Comment from Applicant

Docket #055-77392

RO Question #17

Licensee Recommendation

FIGURE 1
Page 1 of 1

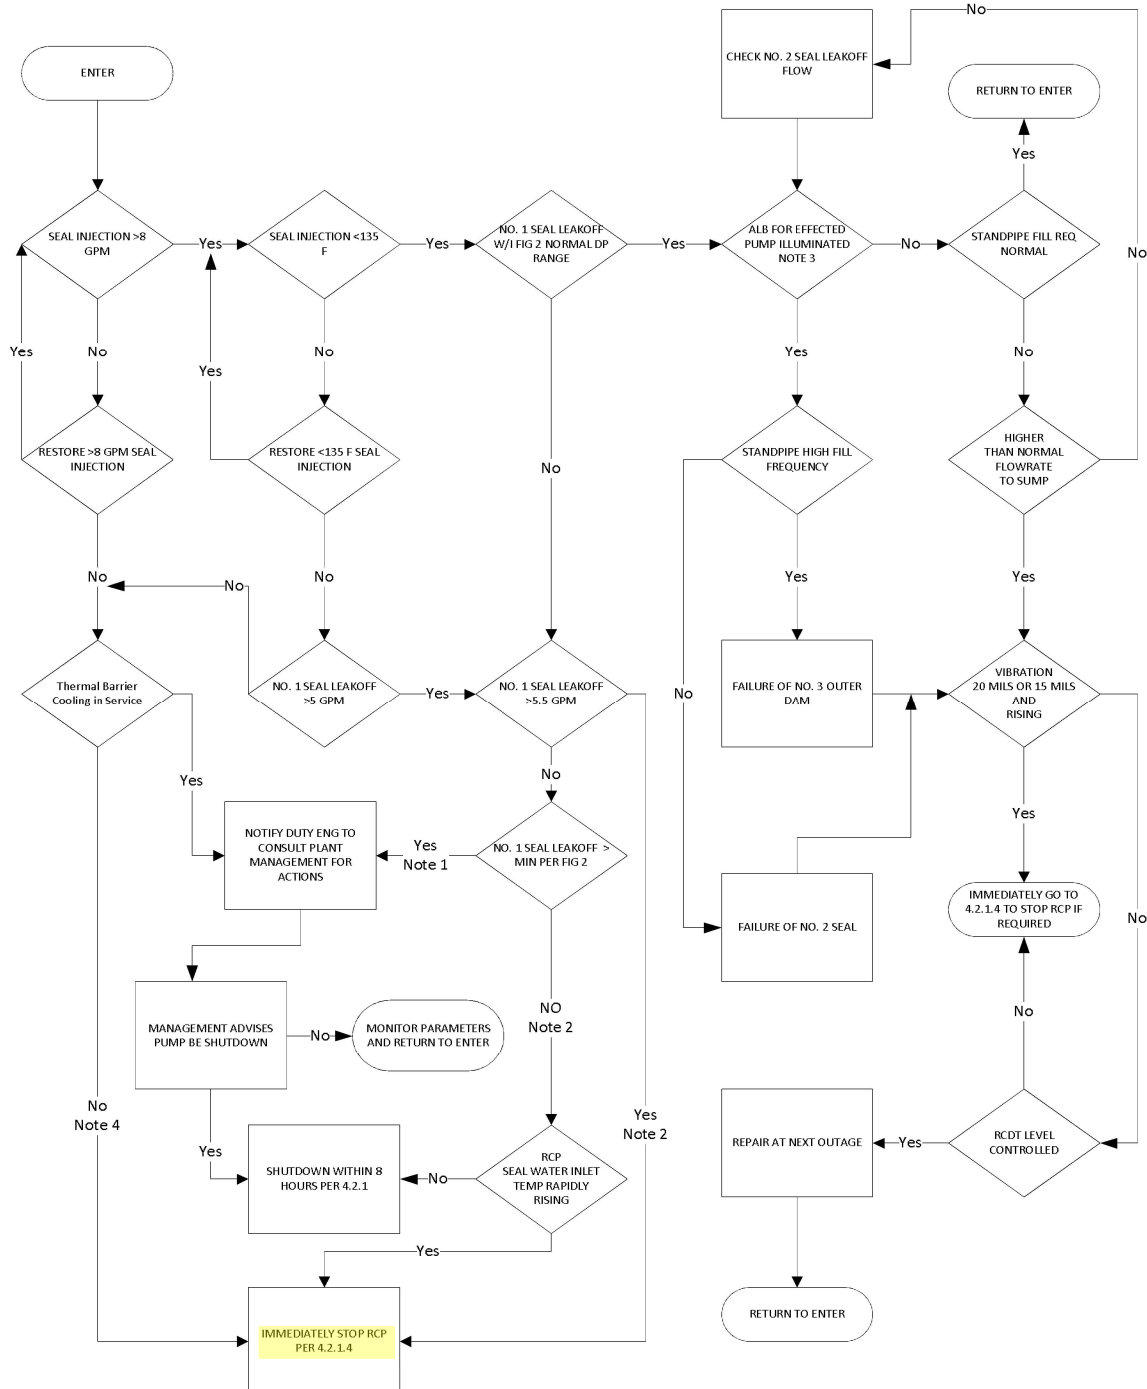
- **13003-1 Reactor Coolant Pump Operation Figure 1** states "IMMEDIATELY STOP RCP PER 4.2.1.4," and should be interpreted to immediately go to the section for securing the RCP. Section 4.2.1.4 does not require an immediate physical shutdown of the RCP. Instead, it outlines a series of steps:
 - Shift Supervisor permission.
 - Start the oil lift pump.
 - Trip the reactor.
 - Perform the immediate operator actions of 19000-1, E-0 Reactor Trip or Safety Injection.
 - Finally, stop the RCP.

Based on the conditions provided and the wording of the question, the correct choice is "C." The term "immediately" should be interpreted in the context of the physical actions performed. The operator must first obtain permission, start lift oil pump, and trip the reactor before stopping the RCP, as specified by the procedure. Therefore, choice "C" accurately reflects the correct answer of RCP 'is not' required to be immediately shutdown.
